FIELD DATA SHEET
HOWARD COUNTY WELL YIELD TEST

Well Permit No. HO - 92-0361
 Location of property (road) KANDRUP DR.
 Subdivision BEAUFORT PINE SEC. III AREA C Lot 11 Block Plat Sec.
 Well Driller J. MAYNE Owner RDBT DAFER

APPLICATION FOR PITLESS ADAPTER, WELL PUMP AND PRESSURE TANK INSTALLATION

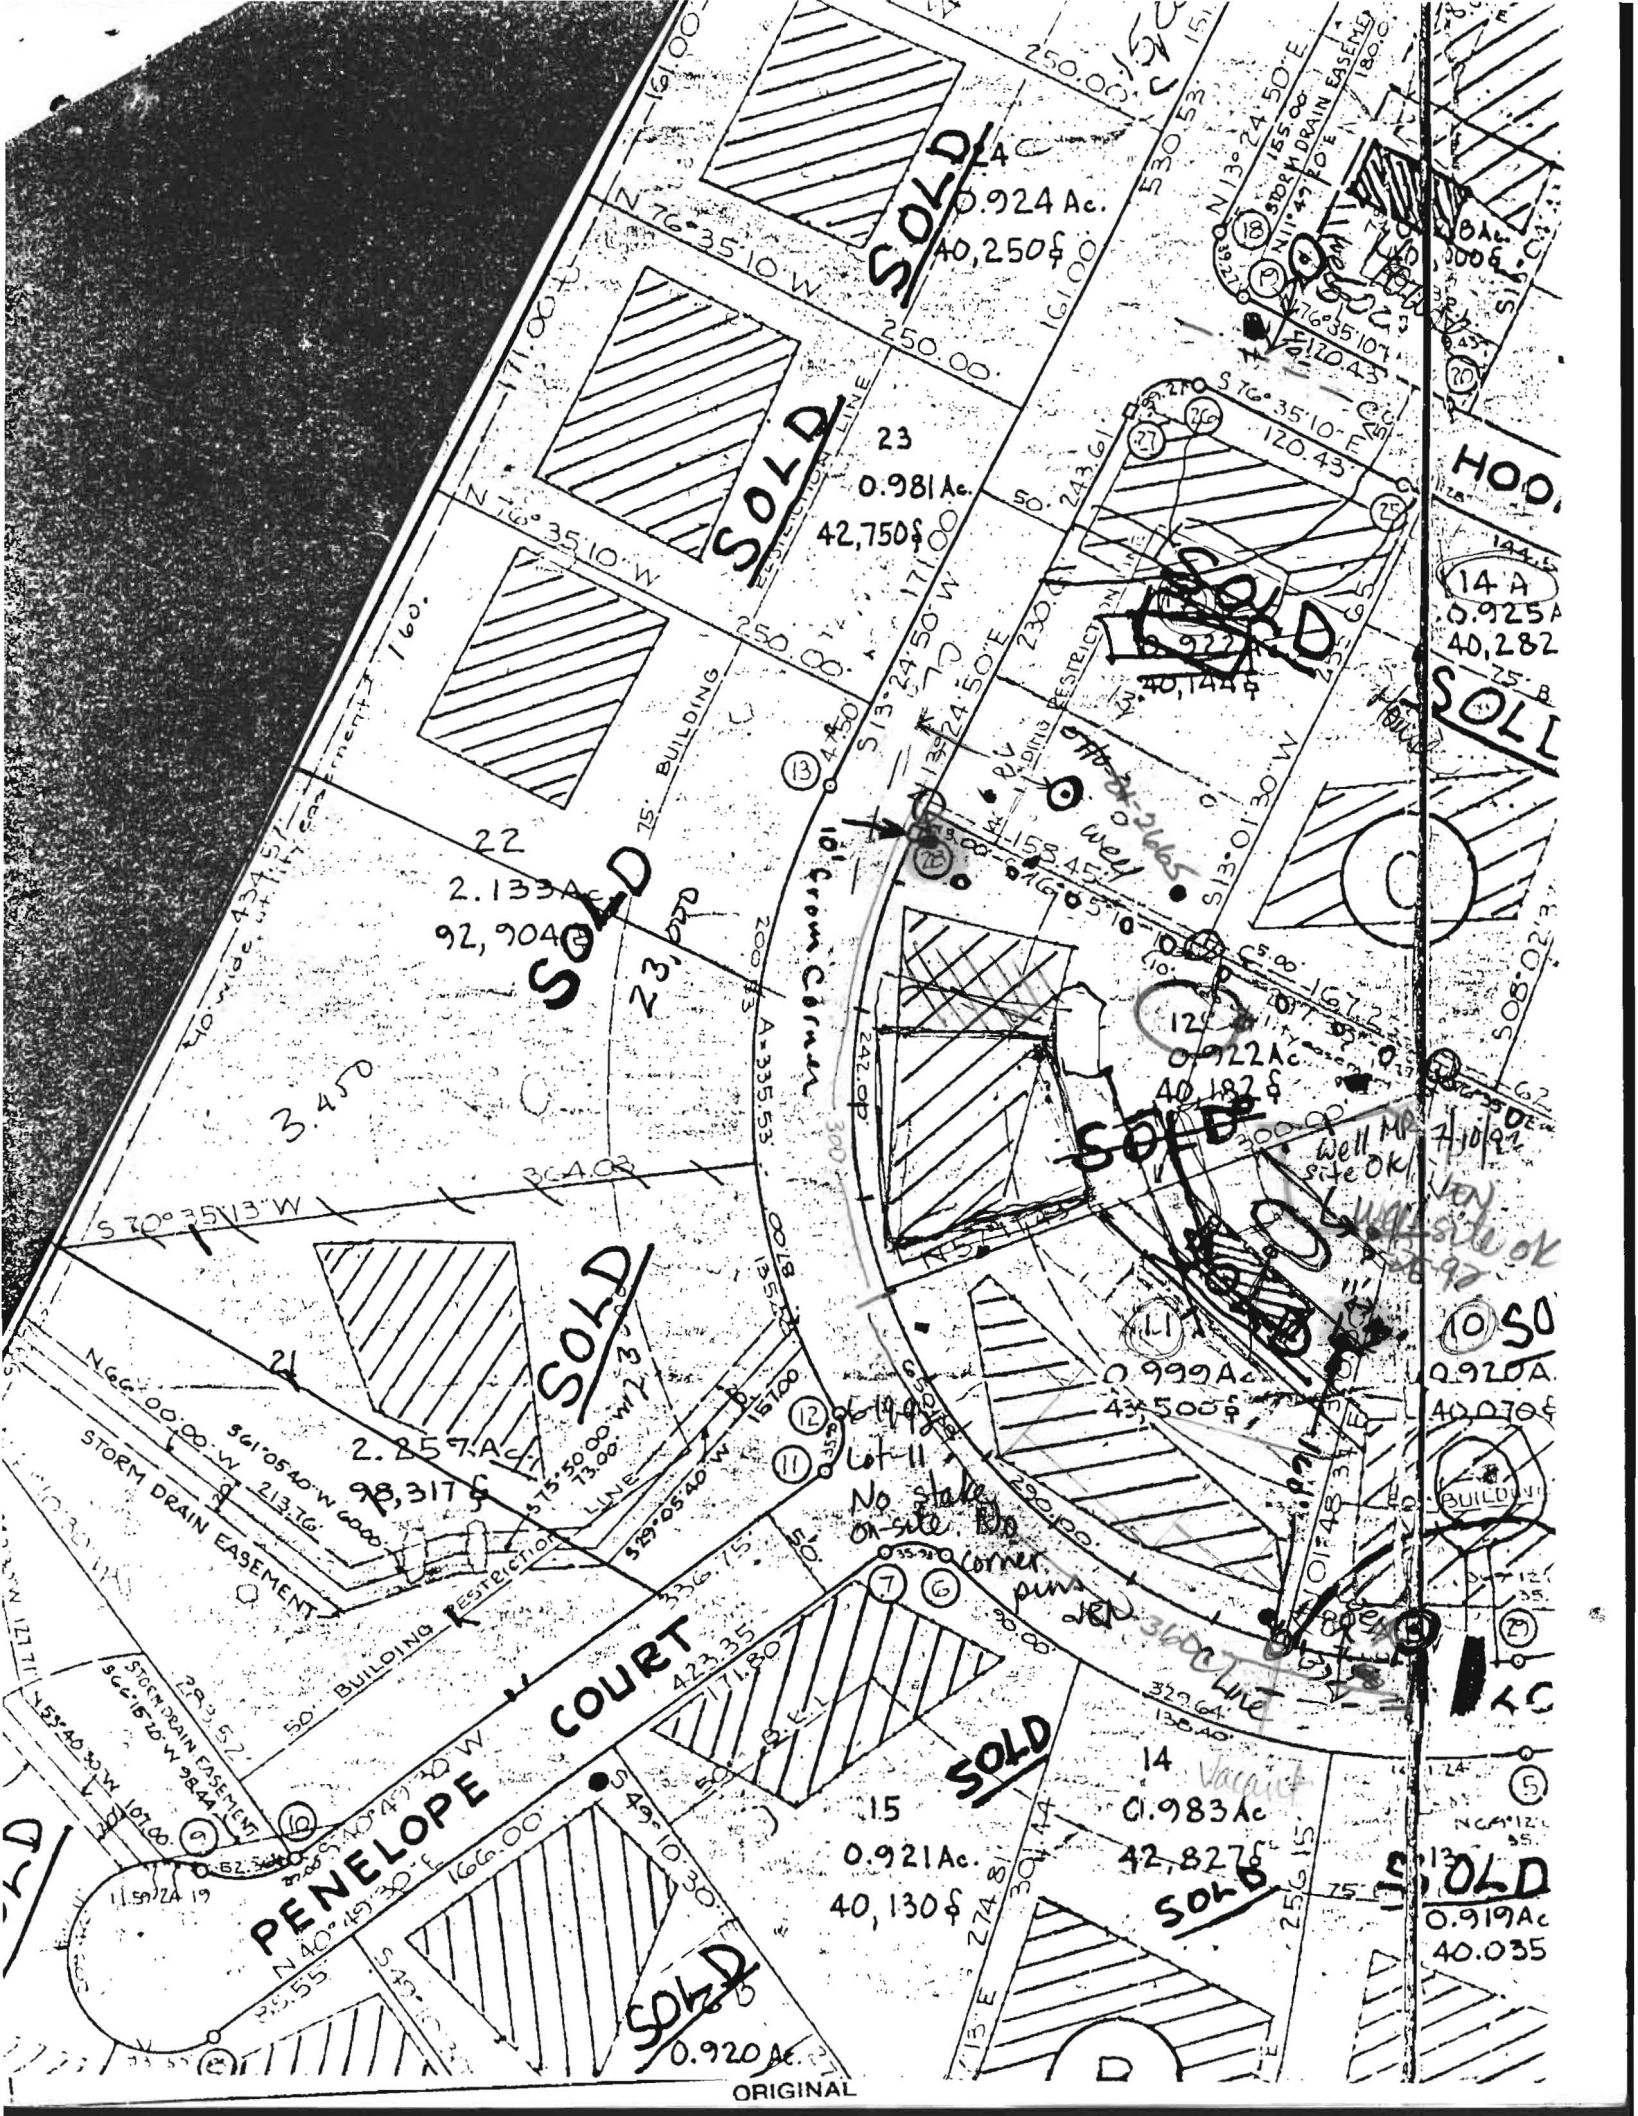
TRENCHES

210 sq. ft./bedroom

Trench to be 2 wide.

Inlet 4 feet below original grade.

Bottom maximum depth 8 feet below original grade.

Effective area begins at 3 feet below original grade.

4 feet of stone below distribution pipe.

LOCATION: START THE FIRST TRENCH 90' DOWN THE
LEFT LOT LINE AND 15' OFF THAT LOT LINE,
RUN TRENCHES ALONG CONTOUR TOWARD RIGHT
SIDE OF LOT.
